Summary Report of Waterview Tunnel Operation - July 2017 to June 2018

Review of compliance with operational air quality conditions

Prepared for Waterview Tunnel Joint Operation

19 October 2018

Figure 3: The proposed location of the portal air quality monitoring station (marked by X) relative to the worst case modelled receptor at the southern portal (marked by the red dot)

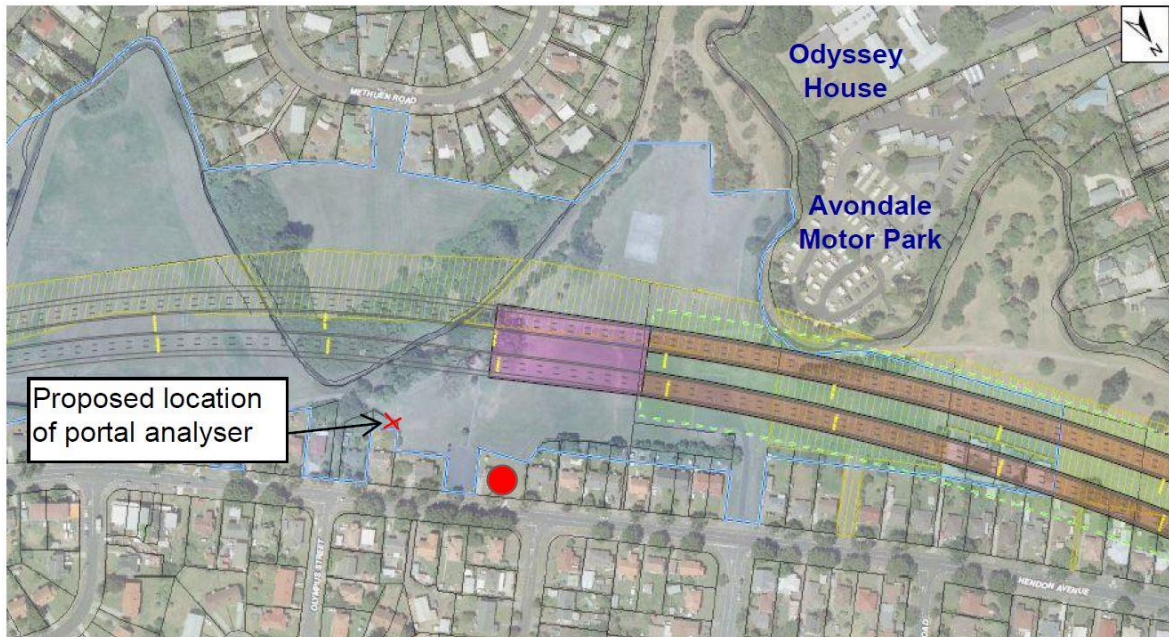
We agreed that the proposed location of the portal air monitoring station (shown in Figure 3) was the best practicable location for capturing worst case portal emissions effects, given the constraints for this area.

WCA proposed locating the analyser at the southern end for a minimum period of a year and then, depending on the monitoring results, potentially shifting it to the northern end at a site closer to the Waterview School (if a unit with a smaller siting footprint could be sourced).

From our review of the monitoring results to date (see section 4) we do not consider shifting the portal monitor to the north to be necessary as we consider that northern ambient air quality monitoring station is likely capturing the worst case effects of any northern portal emissions.

Figure 4: Comparison of the daily NO₂ averages recorded by the two analysers over the co-location period

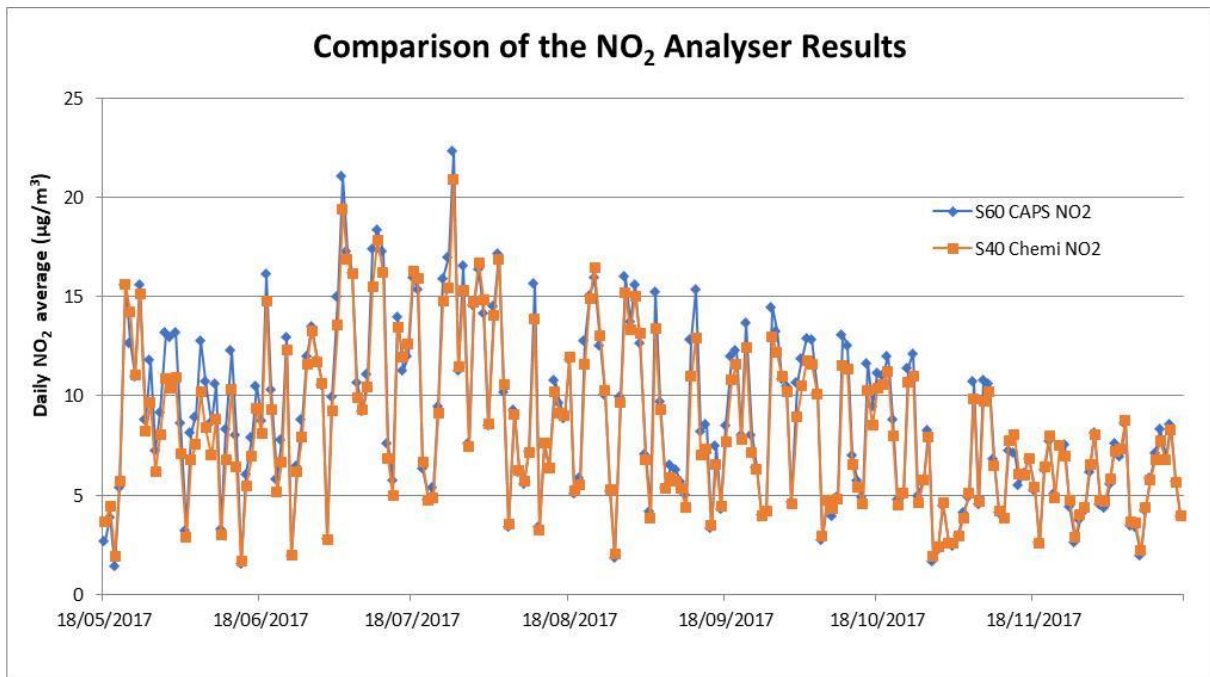
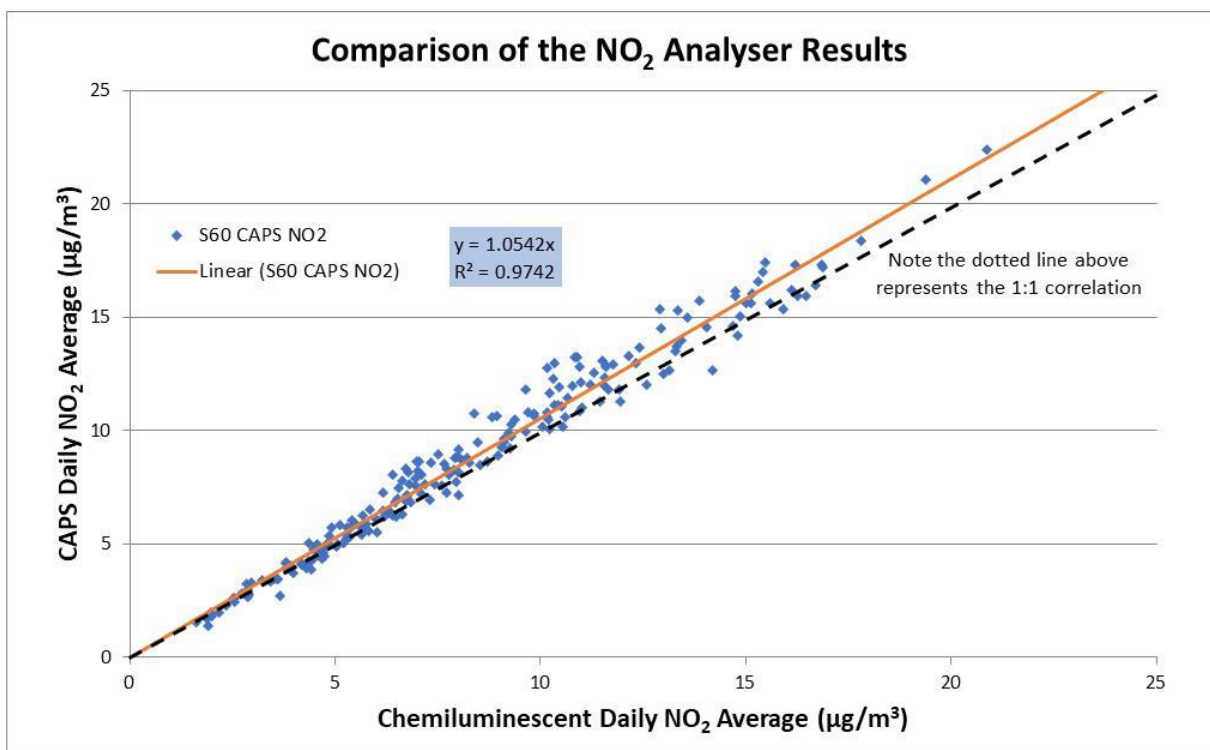
While the CAPS analyser did not strictly meet the requirements of Schedule 2 of the NES, we agreed to its deployment provided it was co-located with a reference (chemi-luminescent) analyser for several months to demonstrate comparability.

Figure 4 shows the results of the two different analysers track each other well, which is further confirmed in Figure 5 with a high degree of correlation ($R^2 = 0.9742$). The CAPS analyser, if anything, appears to be more responsive to NO₂ (reading 5% higher on average than the chemi-luminescent analyser).

From these results, we agreed that the CAPS NO₂ analyser was appropriate for monitoring worst case portal emissions.

Figure 6: Trends in monthly average daily traffic since the tunnel opened

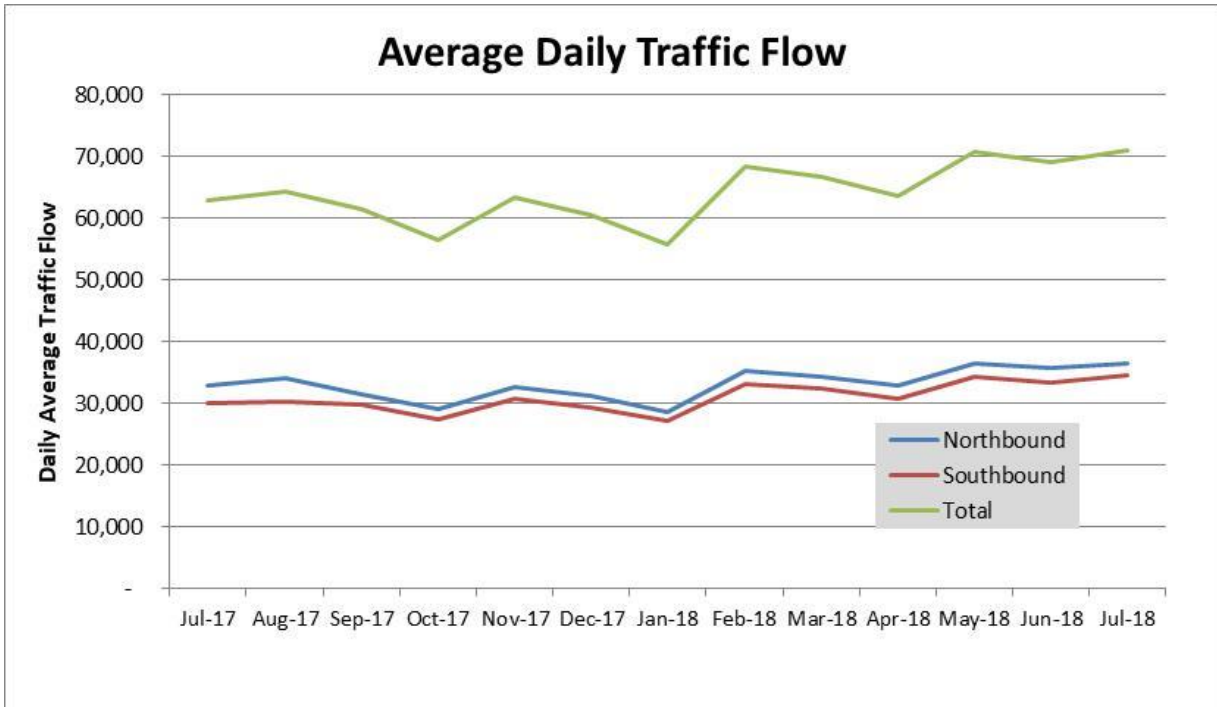
As a cross-check we requested the traffic data to review any trends in average daily traffic numbers over the same 12-month period. Figure 6 shows the change in monthly average daily traffic since the tunnel opened in July 2017. Traffic numbers have steadily increased in both directions over time and for July 2018 are now approximately 12% higher than those recorded in July 2017. Figure 6 shows some month to month variation - e.g. October, January and April are below the overall trend, possibly due to school holidays - but the variability is only a matter of a few percentage points.

This means that the ambient air quality monitoring results to date capture the realistic operating conditions in the tunnel with respect to traffic numbers.
